Subject: Response 7 to U.S. Environmental Protection Agency's Questions on the Replacement Panels Planned Change Request

EPA Letter Date	EPA Question Number	EPA Question Description
September 27, 2024	RPPCR7-BrineRes-1 through 4	Requests related to brine volume estimates made using the two-domain model
April 17, 2024	RPPCR1-DATA0.FM6-7	Lead-Carbonate Aqueous Speciation

Department of Energy Response 7 to EPA's Questions on the RPPCR

Figure 1. Sensitivity analyses based on the long-term steady-state pressure of 169 psig ($R_{\max} = 4050\text{m}$) vs. analyses with the long-term steady-state pressure of 162 psig ($R_{\max} = 3675 \text{ m}$).

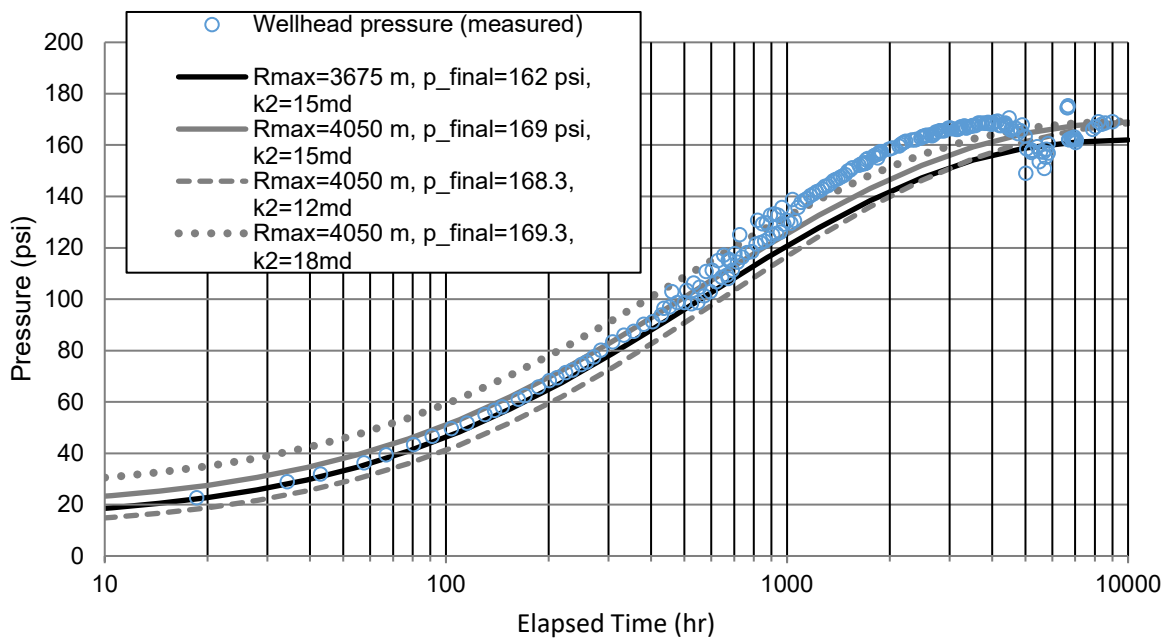
Popielak et al.'s (1983) adoption of 162 psig as the final reservoir equilibrium pressure does not appear to adequately account for uncertainty. Please justify use of this value by Gross and Gjerapic (2022) in calculating maximum reservoir brine volume without considering multiple sources of uncertainty that could provide a reasonable basis for higher equilibrium pressures and larger reservoir brine volumes.

- As illustrated in Gross and Gjerapic (2022, Figures 12 and 13), the wellhead pressure had been declining for about 1500 hours from a peak of 170 psig to a low of between 150 and 160 psig when a gas cap formed that abruptly increased the wellhead pressure to 175 psig in about 960 hours (40 days). When the gas was vented, the pressure dropped to ~142 psig and then quickly stabilized at 162 psig for about 380 hours (16 days) when another gas cap started to form. Given the pressure oscillations occurring before and after the 16-day stabilization period, the uncertainty in assuming that 162 psig represented long-term equilibrium conditions should be evaluated.*

- After the gas cap was vented, the wellhead pressure apparently stabilized for about 16 days (about 380 hours) until another gas cap began to develop. Considering the asymptotic nature of approaches to stability in such systems, were 380 hours enough to strongly support a conclusion that equilibrium pressure had been reached in a test that lasted over 7,000 hours?*

- As illustrated in Gross and Gjerapic (2022, Figures 12 and 13), the deviation of pressure data from the calibrated two-domain model curves, the peaking at 170 psig at about 4,000 hours, and the subsequent decline to between 150 and 160 psig over the next ~1500 hours add additional uncertainty if unexplained. All of this occurred before the gas cap was vented. Did a leak develop in the system? Would 170 psig be a better estimate of the equilibrium pressure?*

- According to Popielak et al. (1983, p. H-14), leaks into the Salado from the uncased, open WIPP-12 borehole could have lowered the buildup pressure by approximately 6 to 7 psi over the long duration buildup period. In considering the importance of anchoring the maximum reservoir volume at a value that is unlikely to be reasonably exceeded, this observation alone would increase the reasonably maximum equilibrium reservoir pressure to 169 psig. EPA considers that this and the other uncertainties described above indicate that an equilibrium pressure of 162 psig may be too low.*

- As an example of the sensitivity of reservoir volume to equilibrium pressure, according to Gross and Gjerapic's (2022) Figure 12, increasing the equilibrium pressure by about 5 psig (from 162 to 167 psig) appears to increase the maximum reservoir radius from 3,675 m to 5,000 m. Assuming the same porosity, an increase of 5 psig could increase the maximum reservoir brine volume by a factor of $5000^2/3675^2 = 1.85$. This would increase the estimated maximum brine volume from $5.90 \times 10^6 \text{ m}^3$ to $1.09 \times 10^7 \text{ m}^3$, which is approaching EPA's PAVT maximum volume of $1.7 \times 10^7 \text{ m}^3$.

The reservoir volumes presented in Figure 12 by Gross and Gjerapic (2022) and the predicted pressure response curves are based on a steady-state pressure of 162 psig at the end of the WIPP-12 testing. Figure 1 shows the evolution of pressure for the WIPP-12 calibration using the maximum WIPP-12 radius (R_{\max}) of 3,675 m as well as simulations for the maximum steady-state pressure of 169 psig after completion of flow testing. A steady-state pressure of 169 psi, the maximum pressure after well venting on March 7, 1983, increased the reservoir volume by about 20 percent.

Additional simulations were used to assess the sensitivity of well head pressure to reservoir radius. At $R_{\max} = 4,050 \text{ m}$, with other calibration parameters remaining the same, the far-field (outer domain) permeability increased by 20 percent relative to those adopted by Gross and Gjerapic (2022). The resulting WIPP-12 volumes, assuming a porosity of 2.2 percent for the near-field domain and a porosity of 0.7 percent for the far field domain, are summarized in Table 1.

Table 1 indicates that a 7 psi increase in steady-state wellhead pressure increases reservoir volume of about 20 percent. While Popielak et al. (1983) state, “*The maximum inflow into the Salado Formation, based on shut-in conditions, was estimated to be 25 bbl/day and this in turn could lower the buildup pressure by approximately 6 to 7 psi over a long-duration buildup period*”, their estimates for the WIPP-12 reservoir volume is based on 162 psi being the most reasonable value. The maximum outflows of 25 bbl/day estimated by Popielak et al. (1983) from data that were likely affected by intermittent leaks and measurement errors render a maximum steady-state pressure of 169 psi unlikely. The maximum WIPP-12 reservoir volume estimated by Gross and Gjerapic (2022) may be viewed as an upper-bound estimate. This is because the analysis neglects the influence of rock creep in the Castile (within the confines of the brine reservoir) and the Salado (from the reservoir level at a depth of about 3,017 feet to the top of the uncased borehole at a depth of 1,002.8 feet, see for example, Black 1982). Popielak et al. (1983) noted, “*...if any portion of the late-time buildup is due to rock creep, the reservoir volume estimate will be too large.*” Rock creep in the upper portions of the Salado is likely to be larger than CCA (DOE 1996) estimate (Reedlunn et al. (2022). Therefore, the upper-bound estimate of Gross and Gjerapic (2022) is likely conservative.
